Vogle Project

January 31, 1985

NRC DOCKET NUMBERS 50-424 and 50-425
CONSTRUCTION PERMIT NUMBERS CPPR-108 AND CPPR-109
VOGTLE ELECTRIC GENERATING PLANT - UNITS 1 AND 2
DRAFT REVIEW COPY OF FSAR CHAPTER 13

FIGURE ~~13.1.1~~ ^{13.1.1-2} ~~13.1.1-3~~ ^{13.1.1-3}
~~SHEET 2 OF 2~~

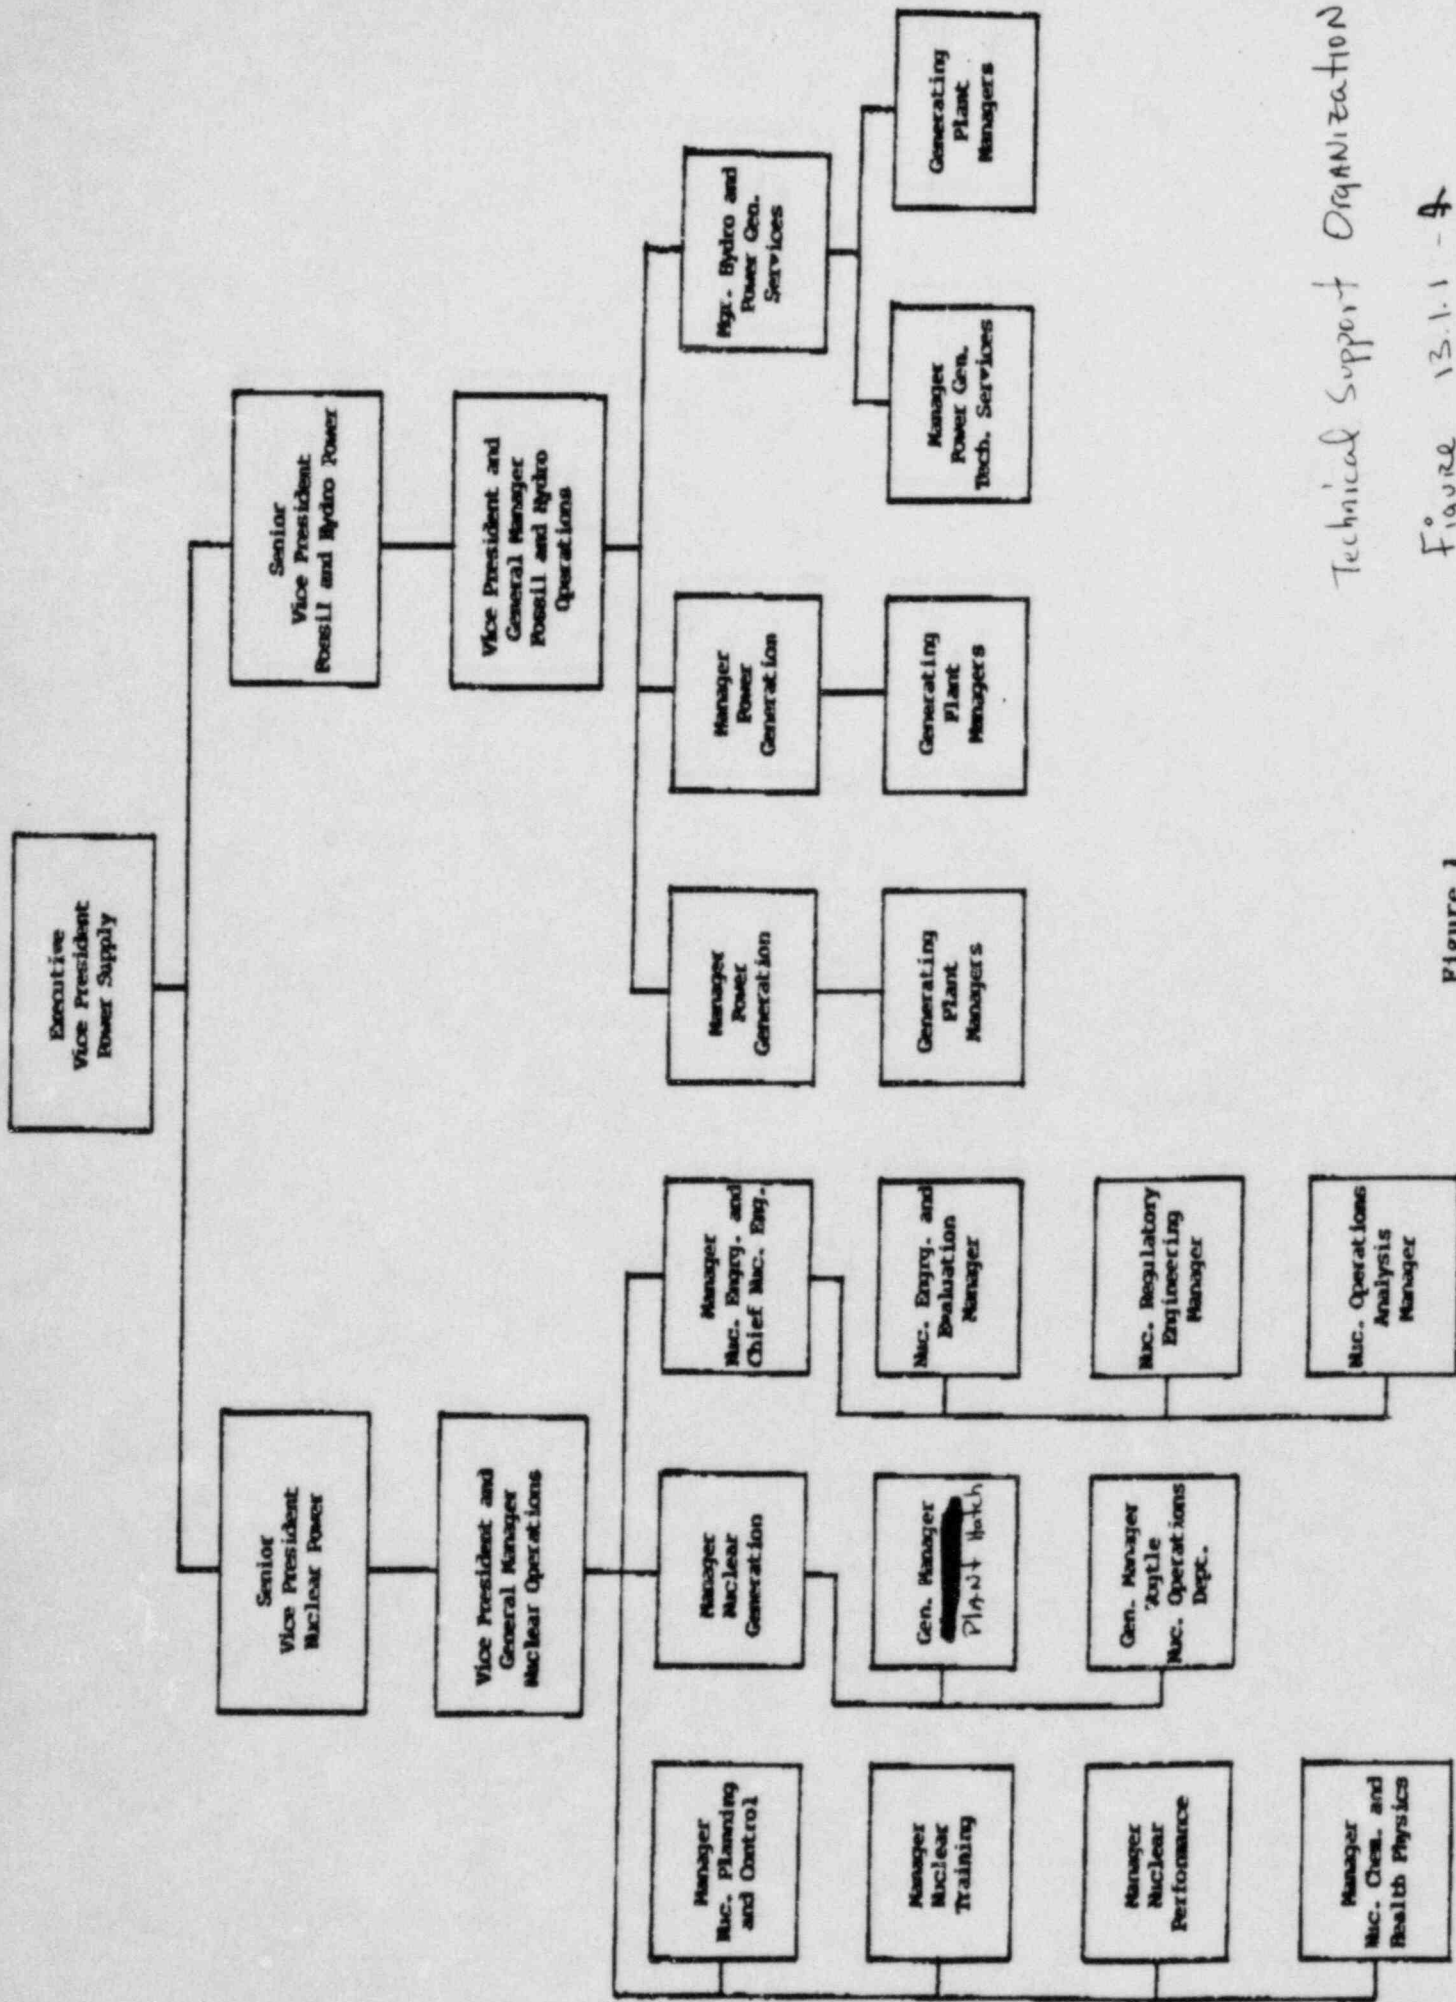
~~TECHNICAL SUPPORT ORGANIZATION~~
POWER GENERATION DEPARTMENT
(UNITS 1 AND 2)
